Powerhouse Ultimo Renewal

Stormwater and Flooding, Response to State Significant Development Comments

Reference: PU2-REP-CI-00X03

B | 15 August 2024

Figure 7 – Afflux at Omnibus Lane, Unmitigated Design Scenario, 5% AEP Event

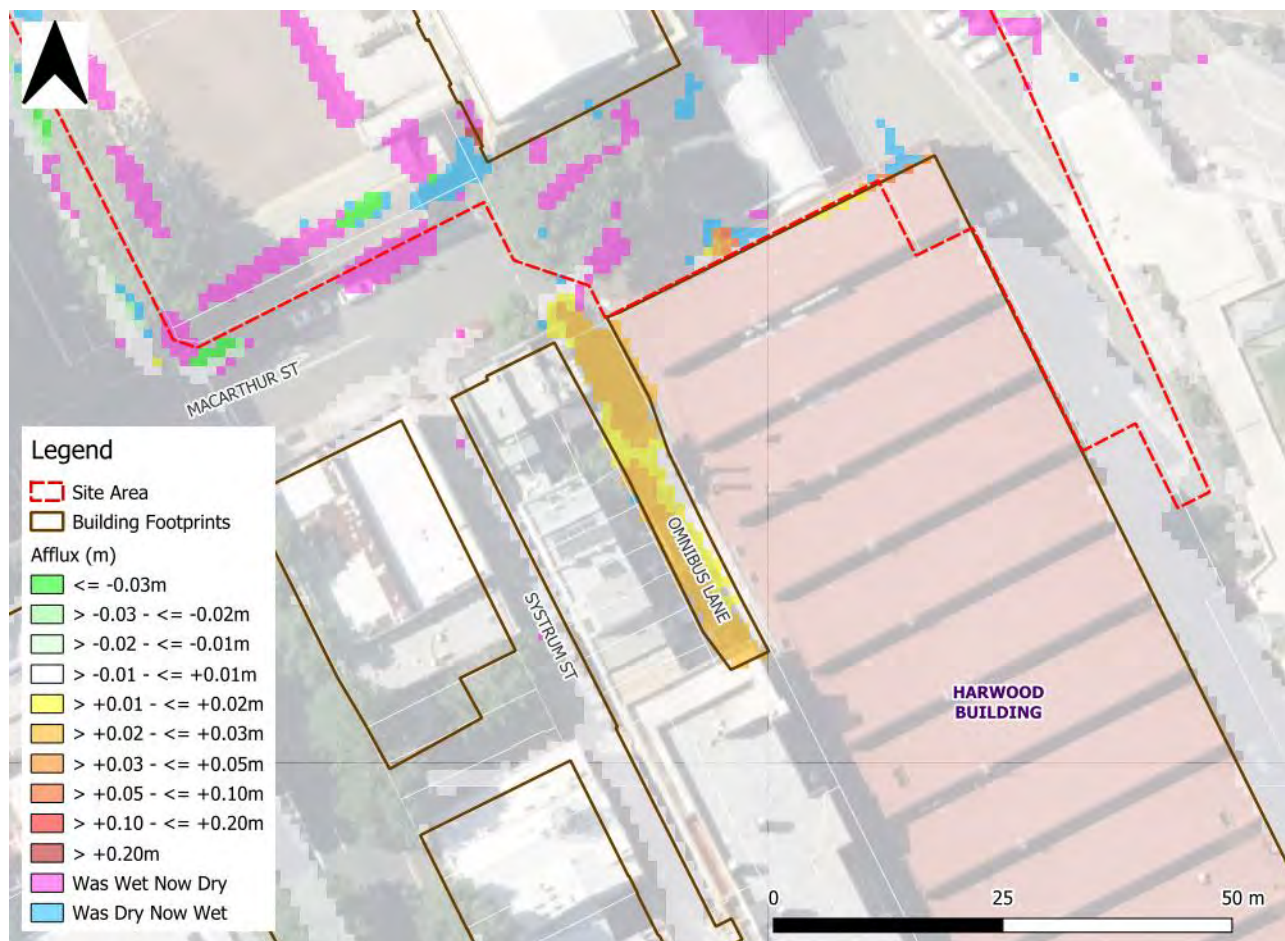
Based on the design inputs listed in Section 2.1.2 (the “unmitigated” design scenario), it was noted there is a material increase in the peak flood levels from the existing conditions within Omnibus Lane in the 5% AEP event. This afflux is due to raised design surface levels (from existing) in Macarthur Street immediately downstream of Omnibus Lane. This results in an increase in the surface flows being diverted down Omnibus Lane, as opposed to flowing east along Macarthur Street towards the Gathering Terrace.

The afflux in Omnibus Lane for the unmitigated design scenario in the 5% AEP event is shown in Figure 7. It is noted that flood level impacts within Omnibus Lane do not vary significantly from existing conditions (that is, peak flood levels do not change by more than +/- 10 mm) in all other events assessed.

FFL Flood Level Check Figure 0
**FFL, 1% AEP Flood Level and
PMF Flood Level Sheet
Overview**

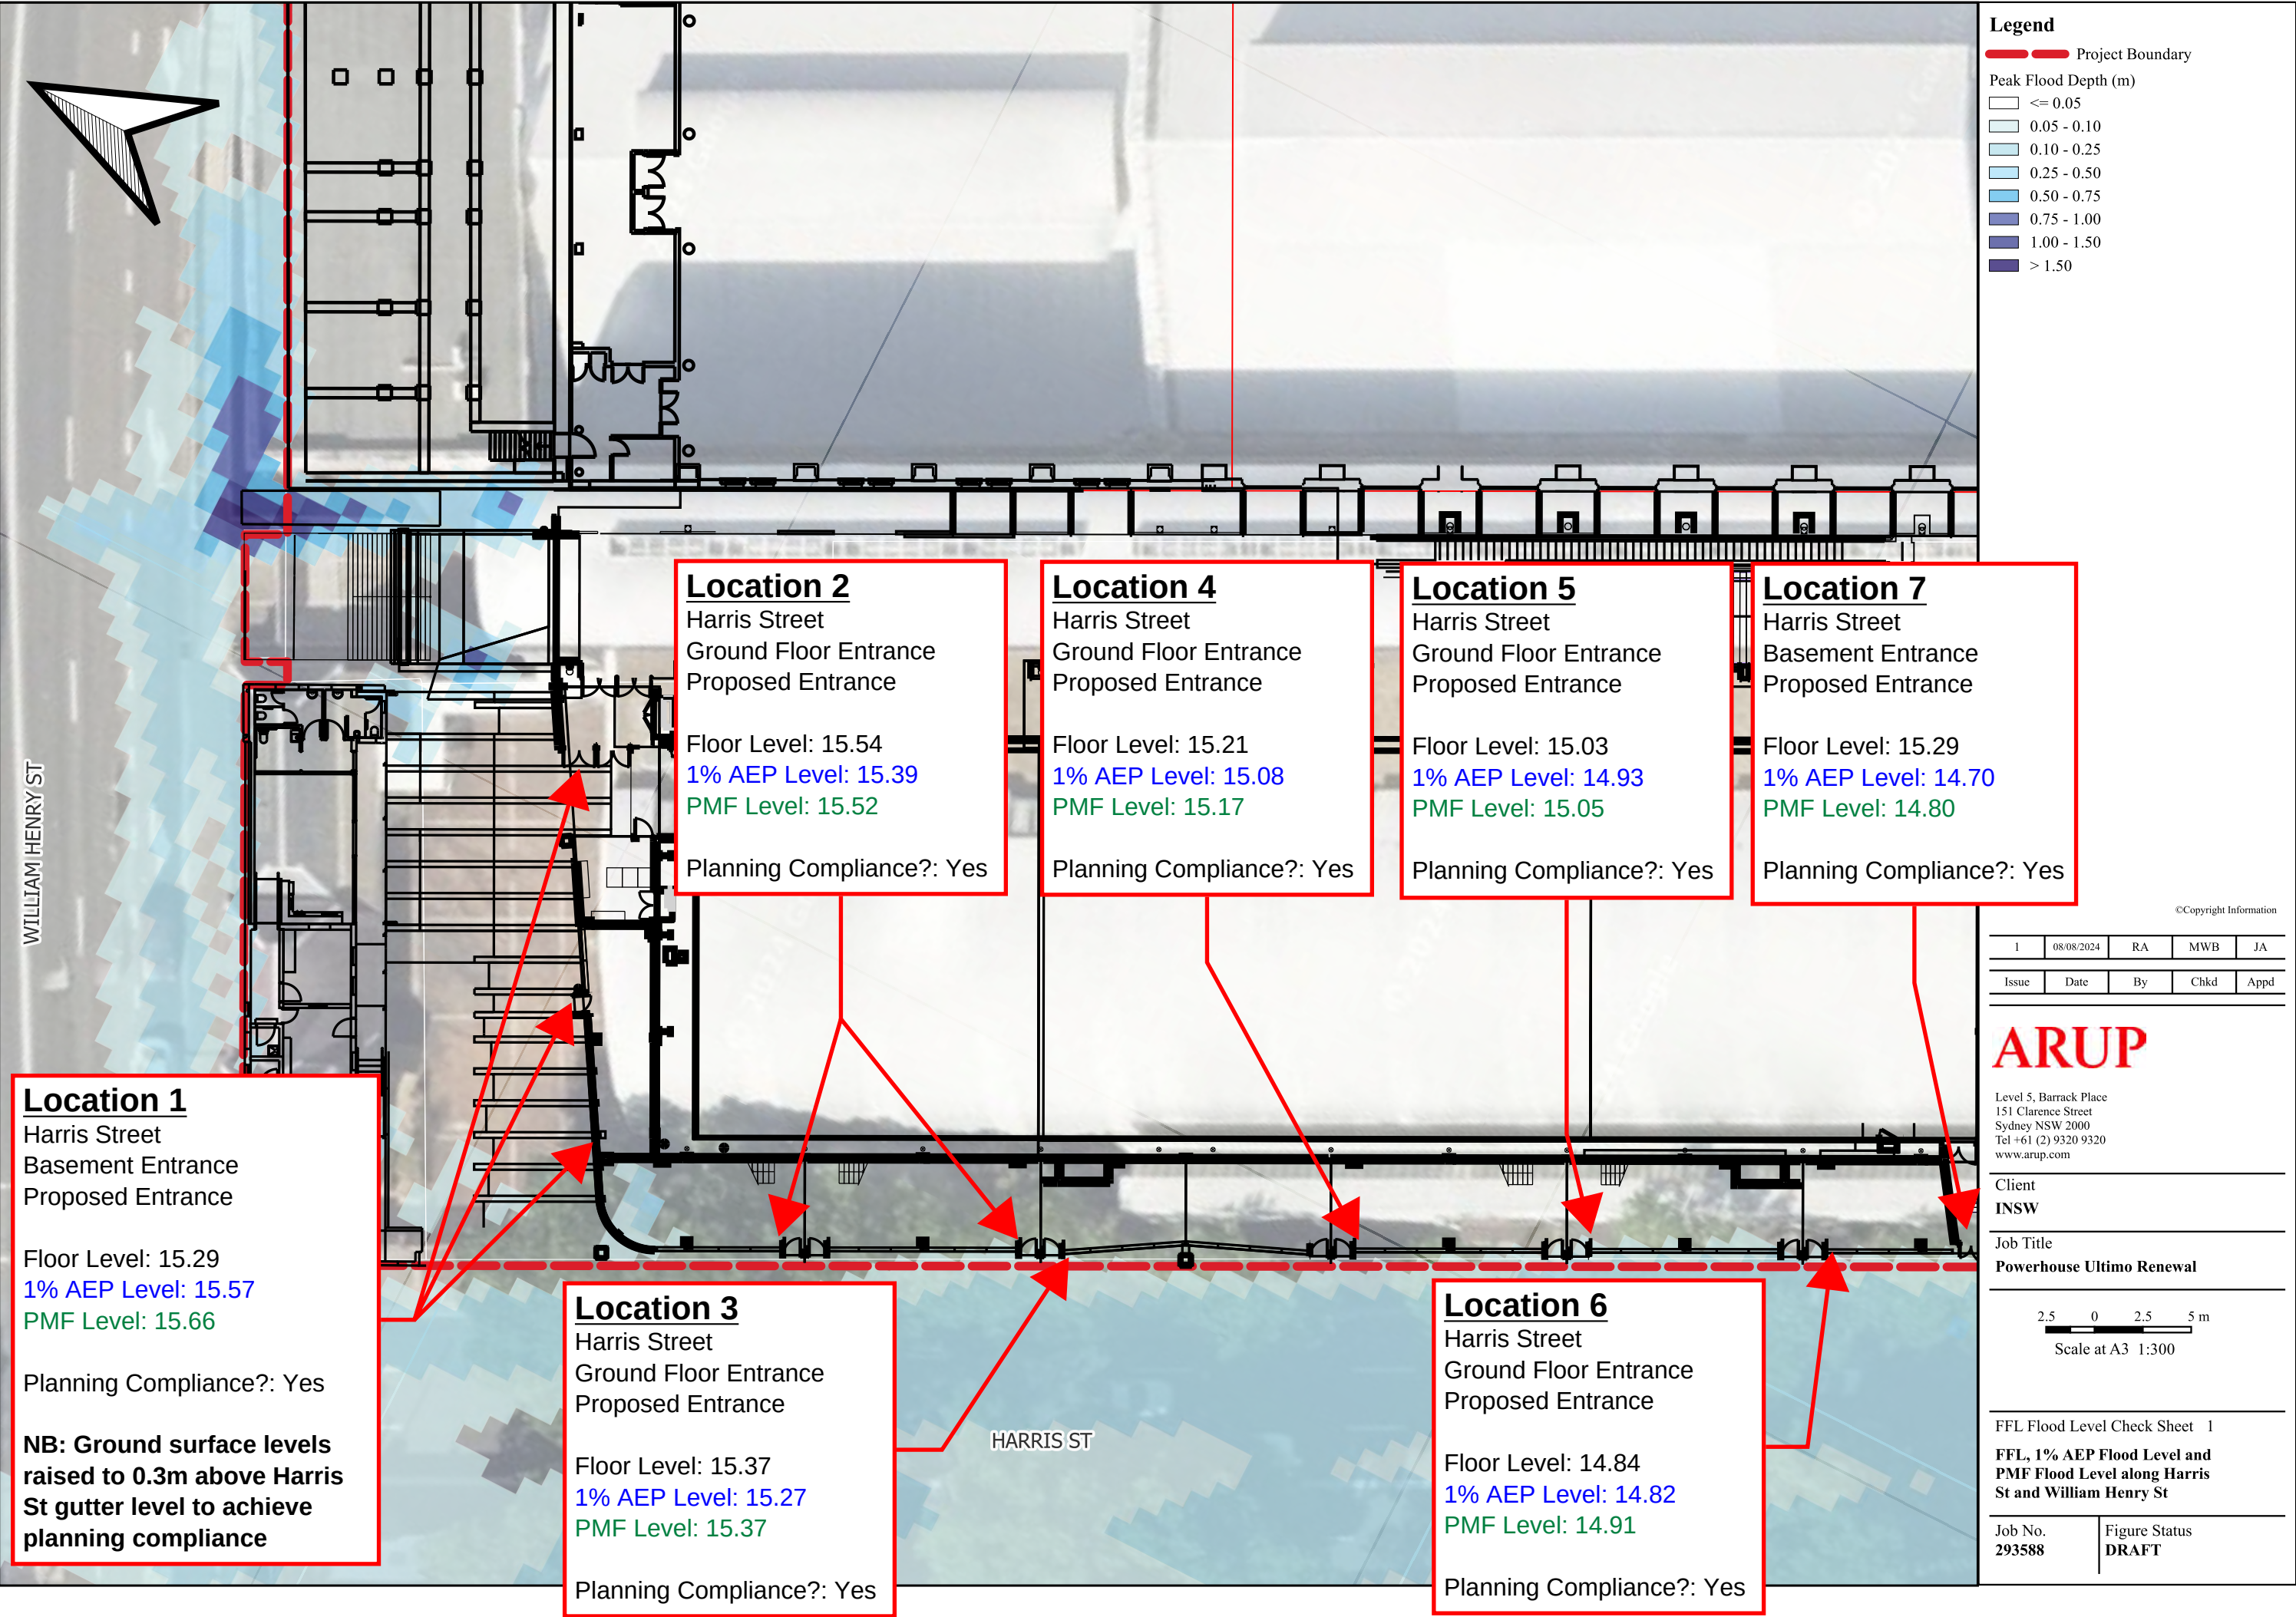
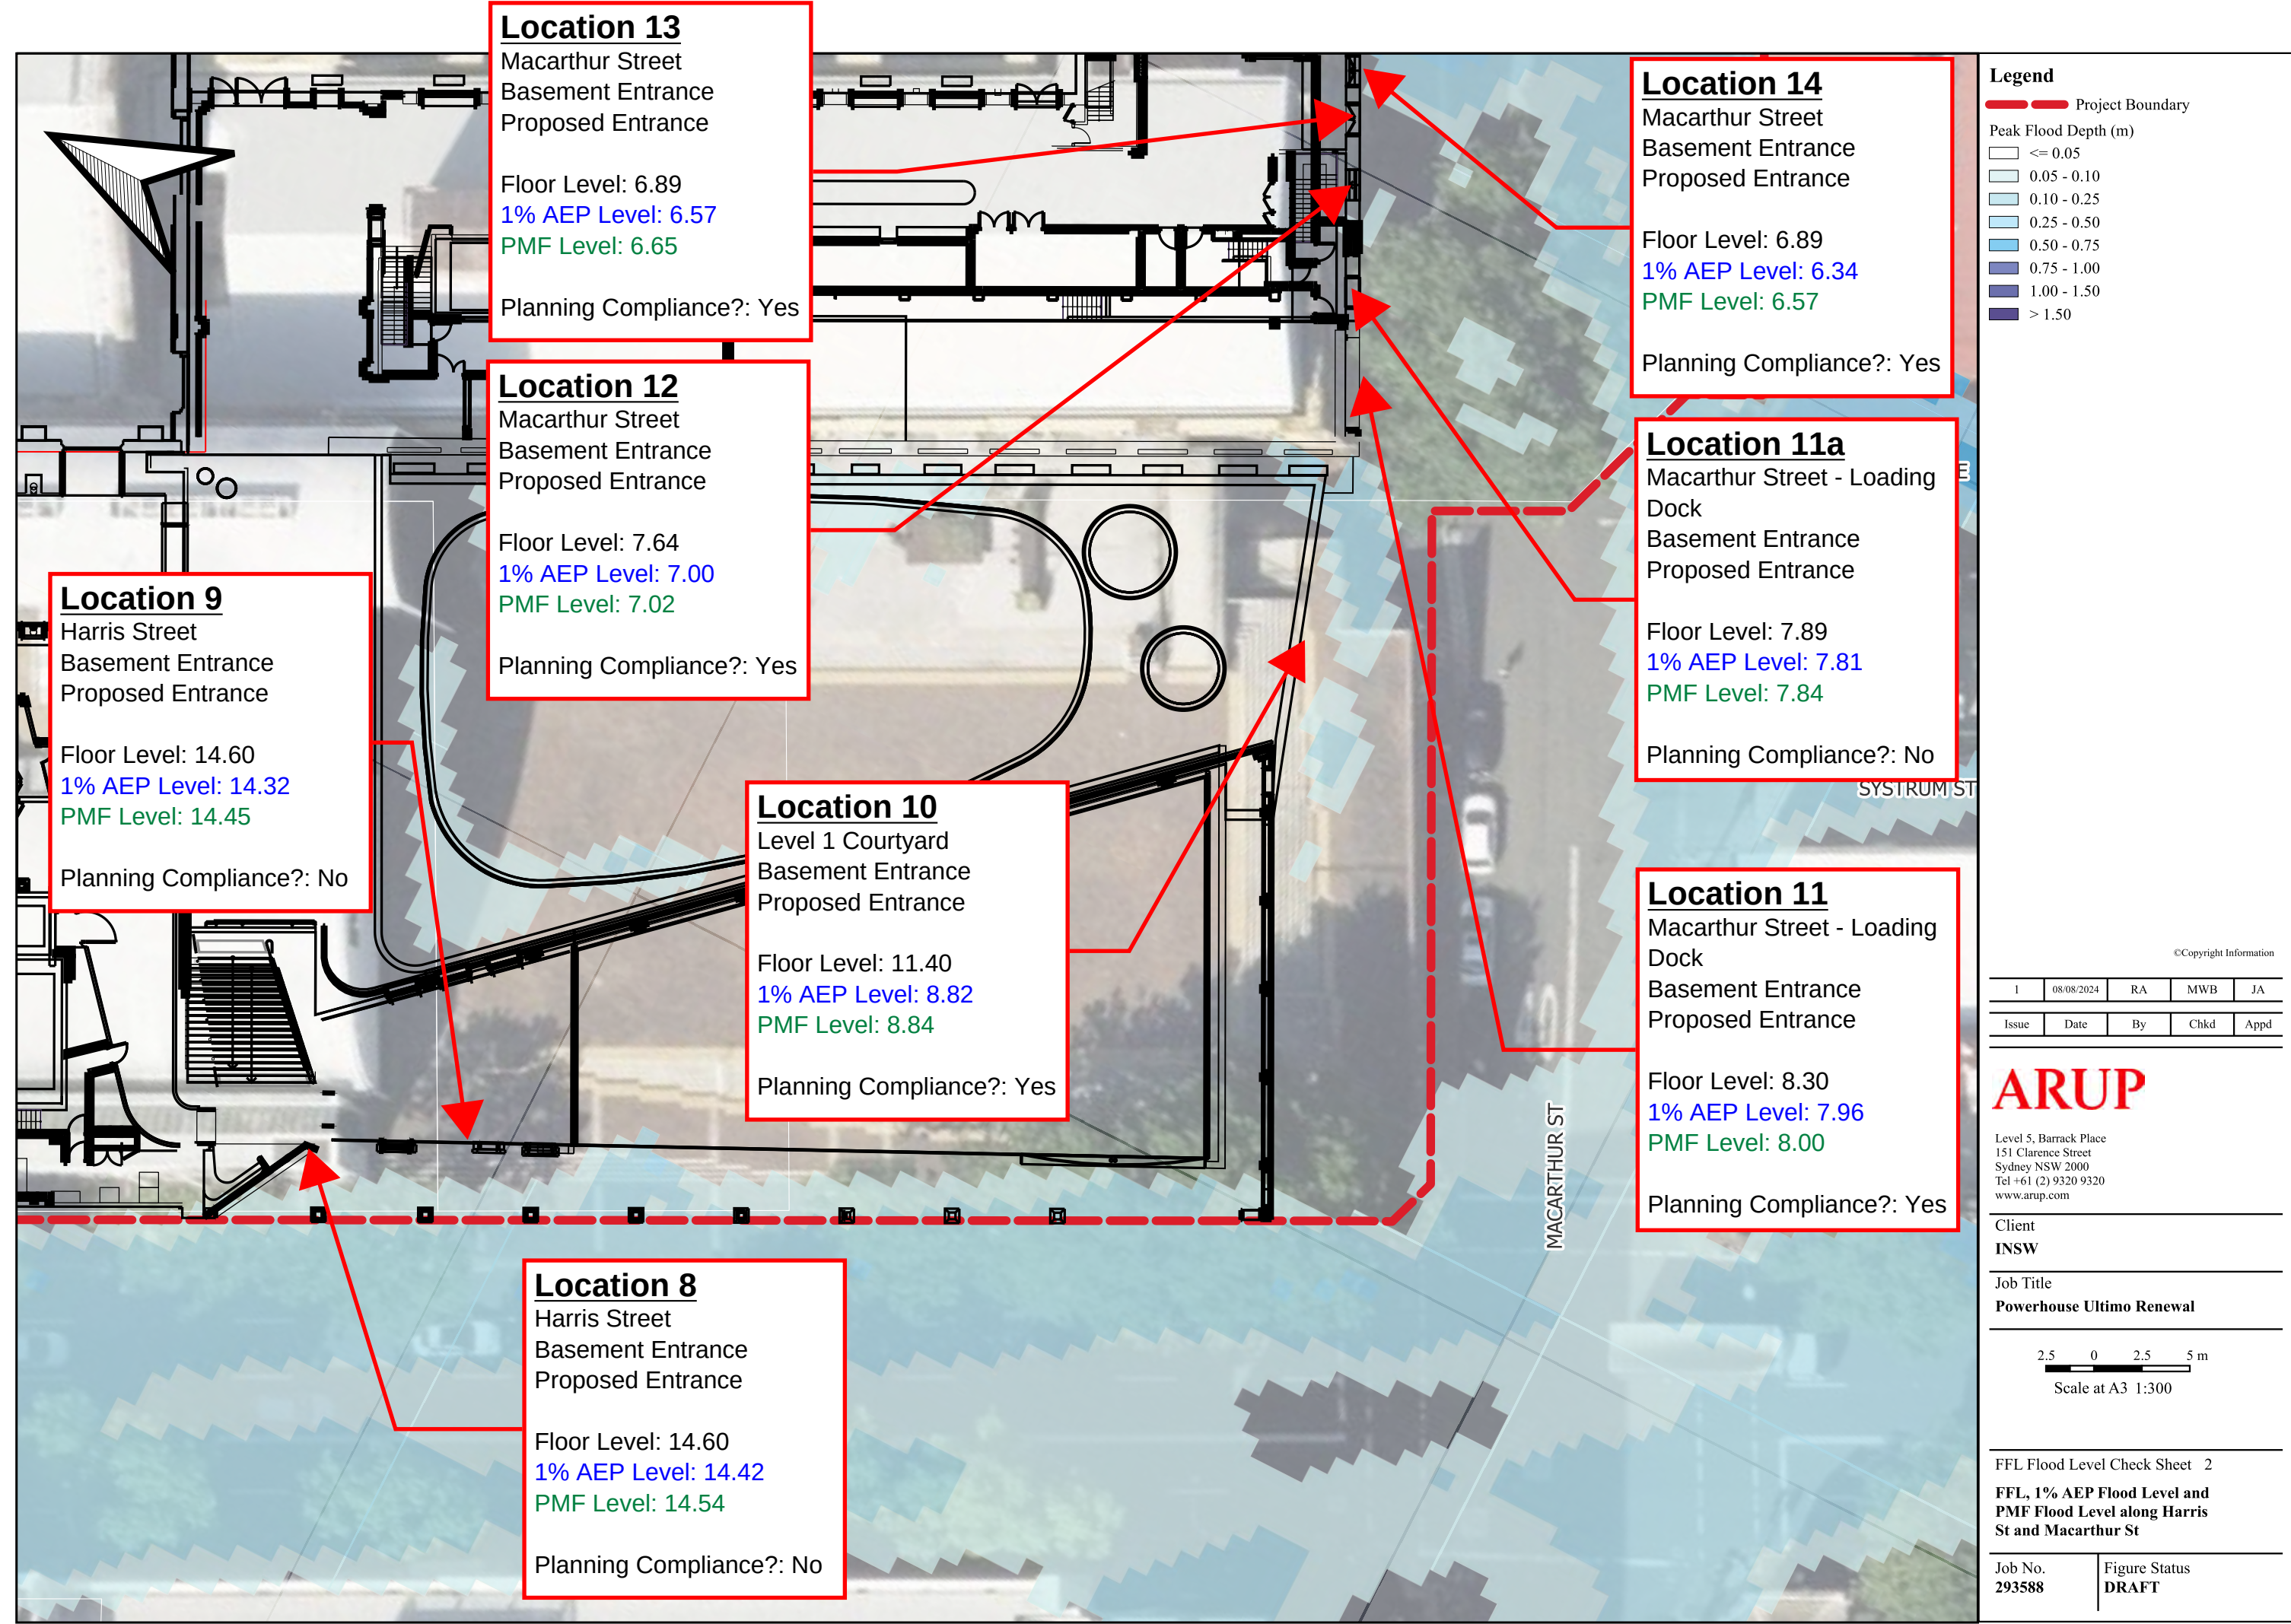
2.3	A plan clearly showing the relevant building entrances together with "flood planning level check locations" shown on Figure 17.	Refer to Section 2.2 (Table 3) and Appendix A.4 for the updated flood level planning compliance assessment.

3.1	The approach to the basement entries needs further clarification. The following should be provided: A plan showing basement entry location and whether these are existing or proposed.	Refer to Section 2.2 (Table 3) and Appendix A.4 for an illustration of the basement entrance locations and updated flood level planning compliance assessment.

In response to comments provided by BCS (listed in Table 1), an updated flood level compliance table (Table 3) has been provided to present flood planning level compliance at entrance locations to the Powerhouse Museum building. Table 3 should be read in conjunction with the figures presented in Appendix A.4, which illustrate the locations of the building entrances.
